SUBJECT: COMANCHE PEAK NUCLEAR POWER PLANT, UNITS 3 AND 4
DOCKET NUMBERS 52-034 AND 52-035
SUPPLEMENTAL INFORMATION FOR RESPONSES TO ENVIRONMENTAL
REVIEW REQUEST FOR ADDITIONAL INFORMATION GEN-03 AND GEN-07

SUPPLEMENTAL RESPONSE TO REQUEST FOR ADDITIONAL INFORMATION

Comanche Peak, Units 3 and 4

QUESTION NO.: GEN-03

Figure 1
Preliminary Conceptual Layout of the BDTF

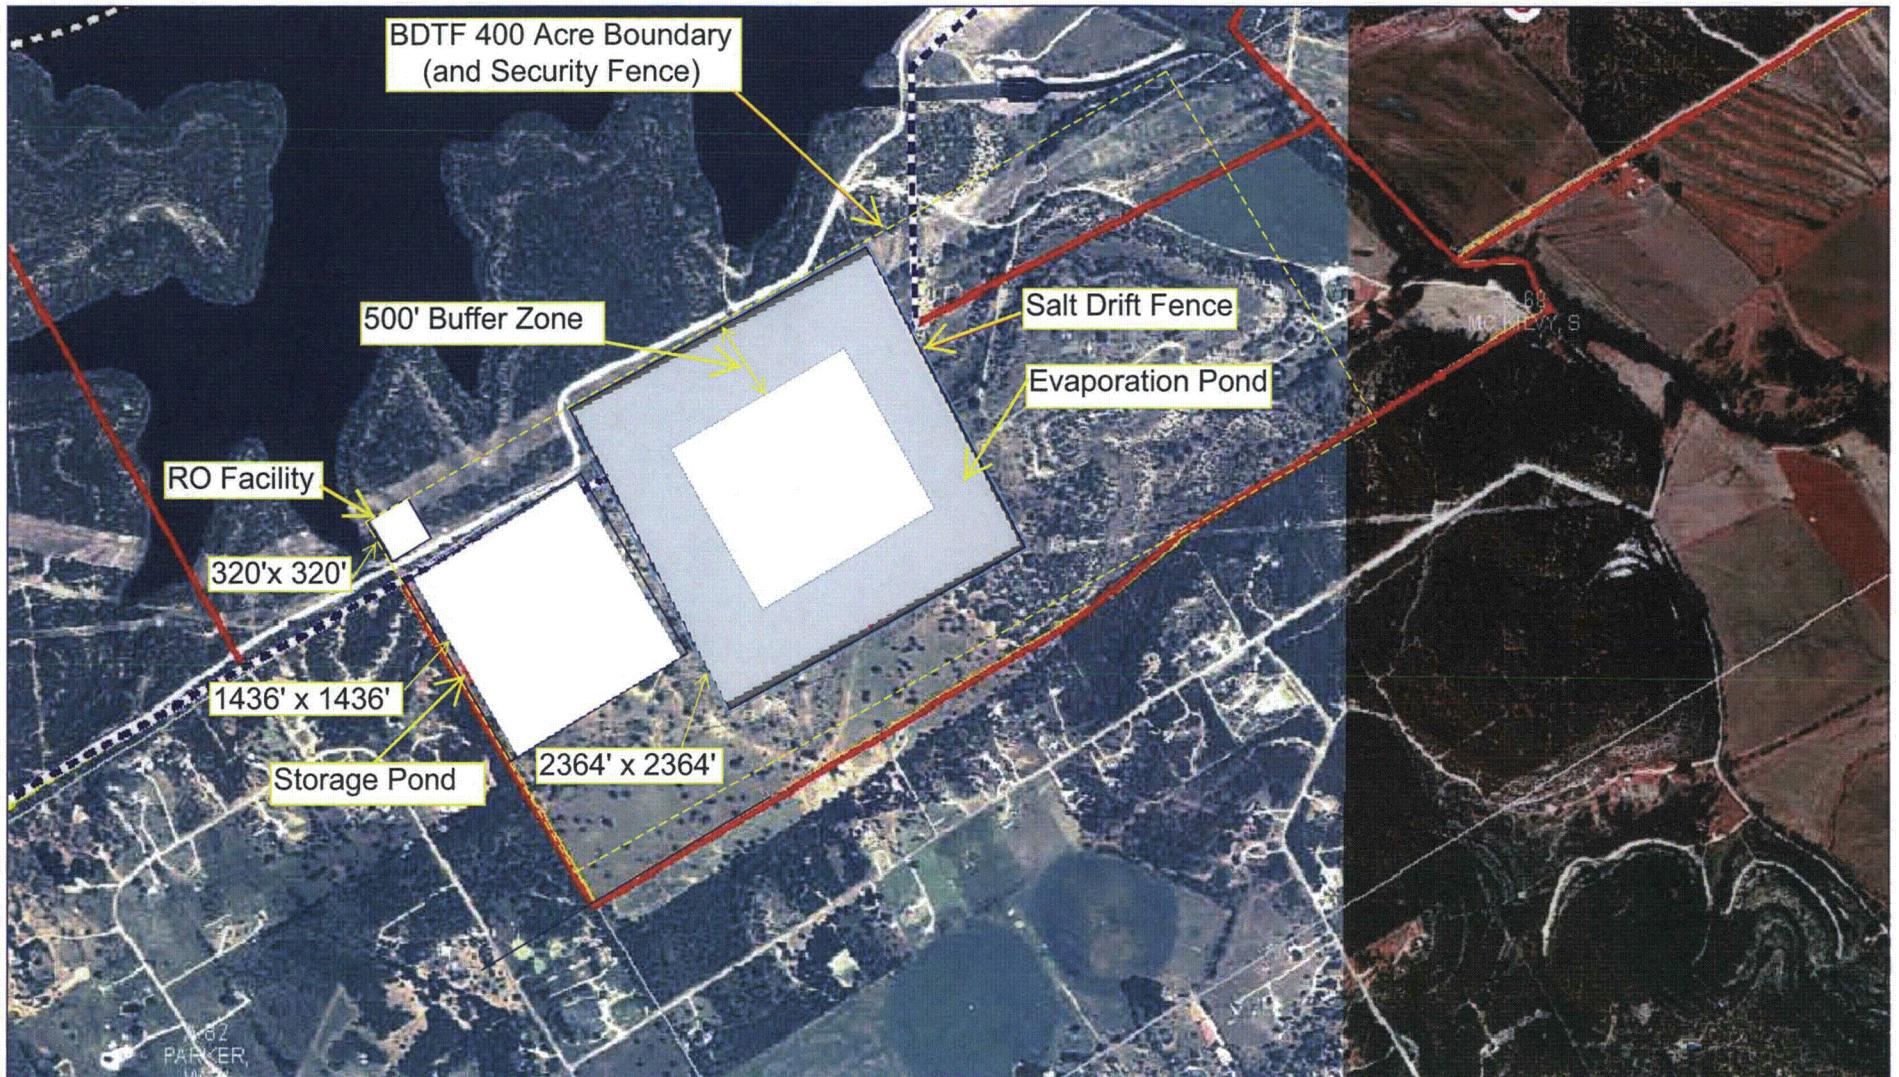
- *A figure showing the layout of the BDTF including the footprint of both BDTF buildings housing the pre-filter/ultra-filter, the reverse osmosis systems, the evaporation and storage ponds, salt drift fences, any buffer strip of land, and the fence line for the site boundary.*

The exact location of the BDTF within the 400 acres has not yet been determined and the layout on attached Figure 1 is conceptual only to confirm that sufficient land has been set aside for this function. There will be a security fence within the designated 400 acres that will surround the BDTF. Based on the salt drift information provided in the responses to RAI TE-21 submitted via Luminant letter TXNB-10013 dated February 24, 2010 (ML100630660) and RAI TE-04 via Luminant letter TXNB-10021 dated March 5, 2010, a salt fence will surround the evaporation ponds and misters within the security fence. A minimum distance of 20 feet between the salt fence and the security fence will allow maintenance of both fences. In addition, a buffer strip approximately 500 feet wide will be provided between the first bank of misters and the outside edge of the evaporation ponds to provide sufficient distance between the mister nozzles and the salt fence barrier to ensure proper functioning of the salt fence. This is illustrated on Figure 1 and drawings entitled "Area Plan BDTF GAS-05-11-100-007" and "Blowdown Treatment Facility Equipment Layout BDT-11-13-400-002" provided in ML100630660.

Please refer to the drawings mentioned above. The area required for the ponds is approximately 175 acres and the chemical facility [ultra-filter/reverse-osmosis (UF/RO) building, storage tanks, etc.] will require an additional 2 to 3 acres. Additional space will be required for access roads, buffer strip surrounding the evaporation ponds and misters, salt drift fences, and security fencing. The entire 400 acres was assumed to be completely disturbed and all buildings will be contained within the 400 acres.

Figure 2
Simulation of Chloride for 1,800 mg/l

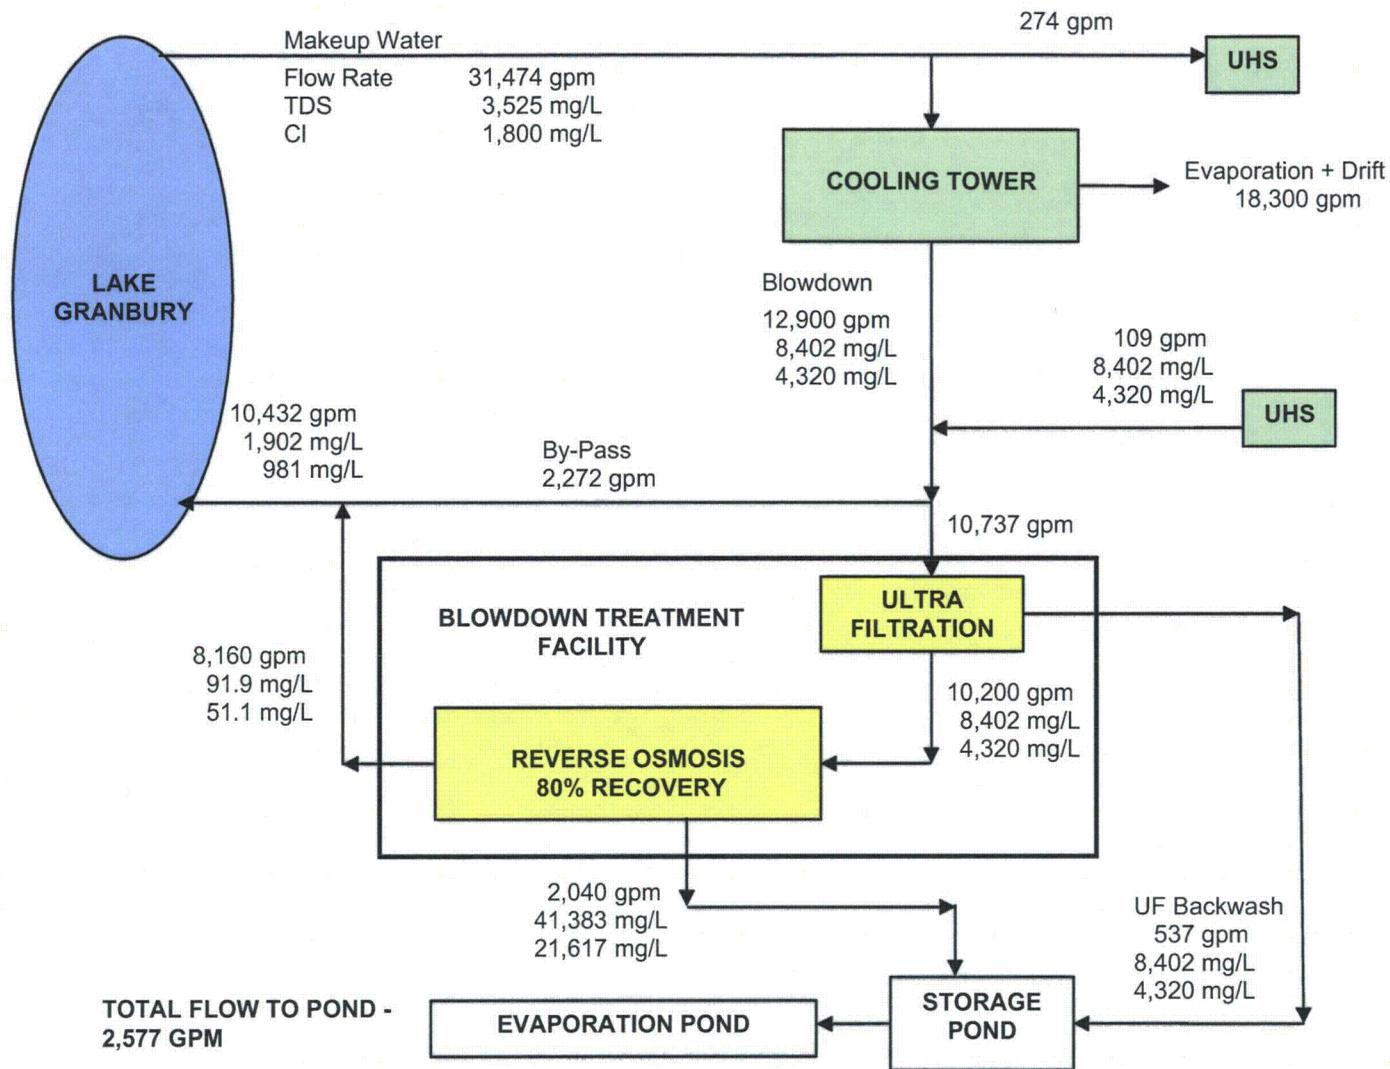
- *The anticipated flow rates and concentrations of solids/salts throughout the circulating water system shown in Figure 3.6-1 (ML093620032) including combined flow rate from the cooling towers and the ultimate heat sink prior to the piping junction for directing flow bypassing the*

BDTF, the flow path into the BDTF, the discharge from the BDTF to the evaporation/storage ponds and the discharge back to Lake Granbury as analyzed for Lake Granbury's current TDS and chloride concentrations (i.e., 2500 or 3525 mg/l).

The waste stream analysis under discussion in RAI HYD-29 and TXUT-001-ER-5.2-007 only includes the periods in which the BDTF is not operating. When the BDTF is operating, the waste stream back to Lake Granbury will be a blended discharge as shown on Figure 2 (attached). The analyte concentrations of the blended discharge are described in Table 1 (attached). This analysis was developed based on the maximum concentrations reported in ER Table 2.3-26, except for chlorides, where the input value of 1800 mg/l was used and the value of TDS was calculated to be 3525 mg/l. The maximum concentration (conservative approach as opposed to using the mean value) was increased by a factor of 2.4 due to the cooling tower concentrating effect, and then it was evaluated using an RO vendor's mass balance equations. This estimate may differ once the actual RO vendor is selected. The blended discharge concentrations for the metals in Table 1 are estimated to be less than the screening levels provided in ER Table 2.3-26 and TXUT-001-ER-5.3-007. Furthermore, the BDTF blended discharge concentrations reported in Table 1 represent the "end of pipe" concentrations and do not account for low-flow or annual mean flow dilution conditions, thus providing a conservative bases for comparison.

The 128-acre (effective surface area) evaporation ponds are sufficient for evaporating a total of 5200 gpm for Units 3 and 4 using 182 misters (Figure 2). A contingency storage volume is provided to allow maintenance of the misters. The combination of the storage and evaporation ponds will provide up to 90-days storage for UF/RO system waste at the 5,200 gpm discharge rate. The 128-acre evaporation pond is 4 feet deep, providing approximately 513 acre-feet of capacity. The storage pond is 32 ft deep, providing approximately 1,505 acre-feet of storage. These values take into account sloped walls, dividers, access ramps, etc. The overall arrangement and dimensions of the ponds may be adjusted during detailed design while maintaining the required surface area and storage volumes.

All of the supporting information for Lake Granbury water quality of 3,525 mg/l TDS, including flow rates and TDS concentrations at various points throughout the system are included in Figure 2. All flow rates and mass loadings in Figure 2 are provided on a per unit basis.

As shown in Figure 2, when the TDS concentration in the makeup water (Lake Granbury raw water) is 3525mg/l, the TDS concentration in the blended discharge into Lake Granbury is 1902 mg/l, well below the TCEQ Surface Water Quality Standard of 2500 mg/l. The quarterly surface water quality data collected for COLA development, and presented in ER Table 2.3-26 does not indicate that TDS concentrations are likely to reach 4000 mg/l. Although peak values could be projected to 4000 mg/l, they are highly unlikely as discussed above.

Figure 3.4-1 Simplified Water Use Diagram

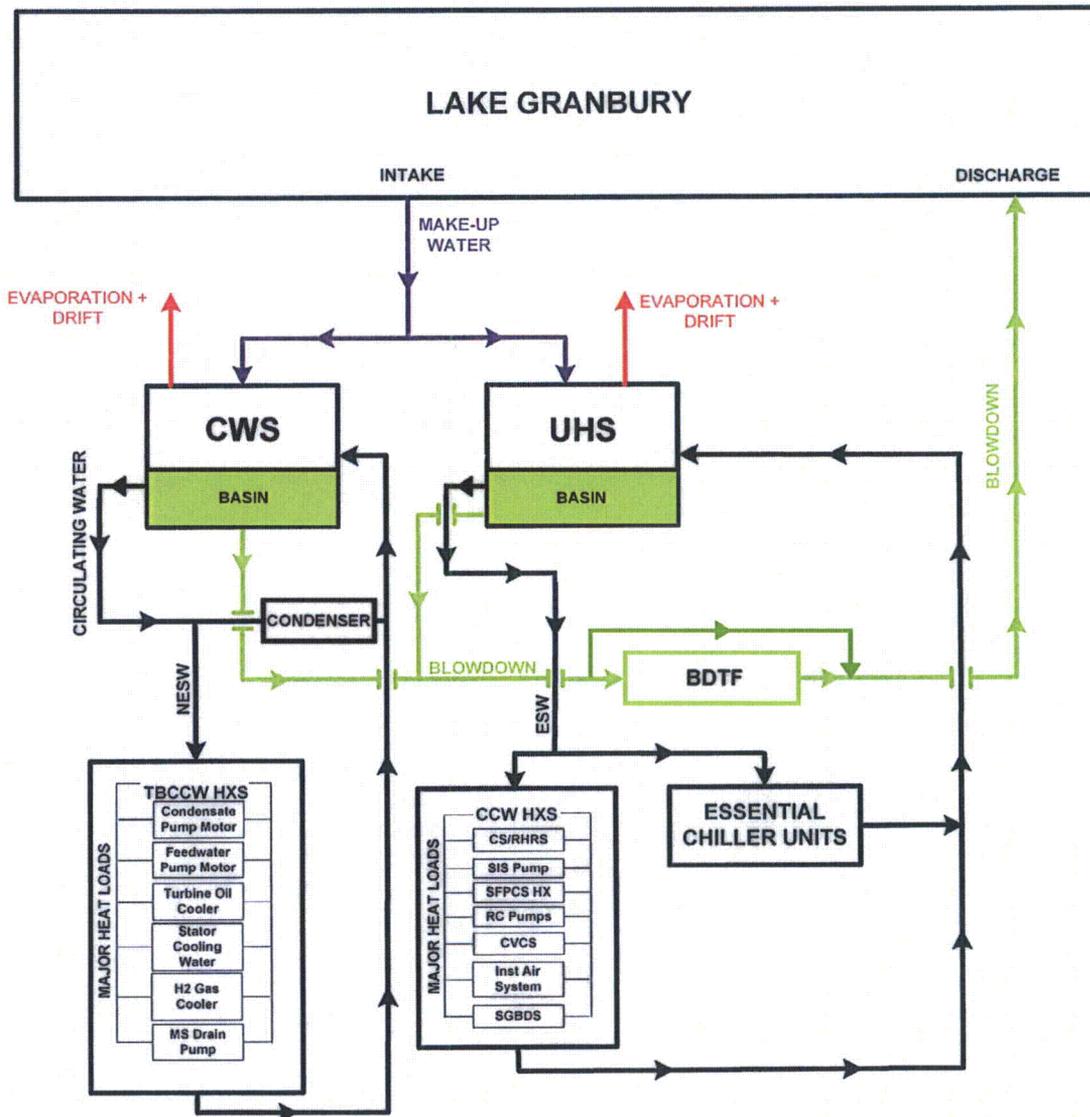
An error was found in ER Figure 3.4-1 submitted in response to this question in TXNB-10013 dated February 24, 2010 (ML100630660). The error has been corrected in the attached revision of the figure.

See attached marked-up ER Figure 3.4-1.
